SAFETY EVALUATION BY THE OFFICE OF NUCLEAR REACTOR REGULATION  
SUPPORTING AMENDMENT NO. 4 TO FACILITY OPERATING LICENSE NO. R-106

DOCKET NO. 50-243

OREGON STATE UNIVERSITY

FIGURE 1

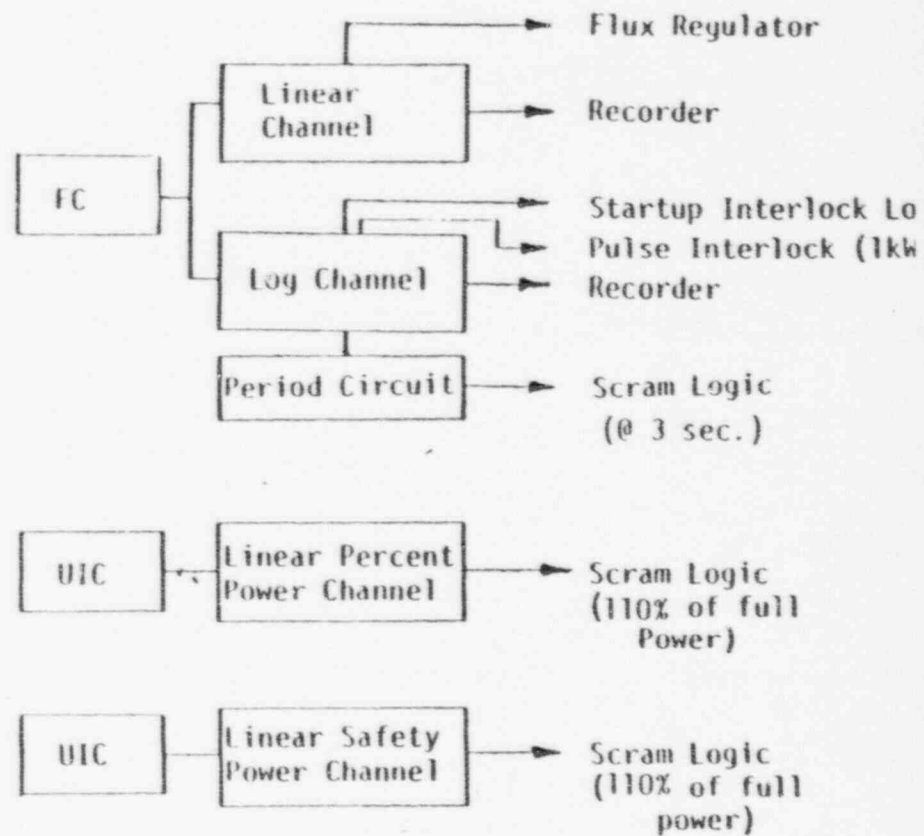
The relationship between the present instrumentation and the new instrumentation is shown in Figure 1.

- (1) Replacing the present multirange linear channel using an ion chamber with the new 9.5 decade linear channel driven by a fission chamber. This same fission chamber is also used to drive the new 10-decade log channel. We view this arrangement as a single "linear-log" channel, as failure of the single detector (fission chamber) means the loss of both linear and log information to the operator.

The present linear channel performs both safety (scram) and control functions. The linear portion of the new "linear-log" channel would provide a signal to the servo system for automatic power level adjustment. The new safety power level channel would provide the scram function.

- (3) Adding a new "safety power level" channel, with scram capability, driven by an ion chamber. This channel would be identical (except for new electronics) to the present percent power channel.

The two channels would use separate ion chambers. This safety power level channel would provide scram capability. This channel, however, would trip only at 110% of full power (i.e., 1.1 MW) whereas the present linear power channel trips at 110% of each range. Block diagrams of the present and proposed design are shown in Figure 1.

Failure of the fission chamber detector in the proposed system causes the loss of both period protection and the control signal to the servo system for automatic power level adjustment. Protection would still be provided by two neutron level trips at 110% of full power and a fuel element temperature trip at 510°C. The licensee has stated that the maximum increase in fuel temperature resulting from this detector failure before a reactor trip (via one of the two level trips) would be about 40°C from ambient, or approximately 60°C.

Therefore, even though period protection would be lost due to failure of the fission chamber in the new design, the increase in fuel temperature would actually be less than that for a similar detector failure in the present system. In addition, the reactivity insertion rates postulated above are not nearly as rapid as during a routine pulse for which an acceptable safety analysis has been documented.

For the above reasons, we find the deletion of level trips at 100% of each range and the period/control circuitry configurations to be acceptable,

We have reviewed the proposed modifications to the OSTR console instrumentation described above, and find these equipment and design modifications acceptable and would not reduce the margin of safety. We have also reviewed the other console electronics included in the proposed package (i.e., pulsing logic, calibration circuits, preamplifier, and power supplies), and have found this instrumentation to be acceptable.
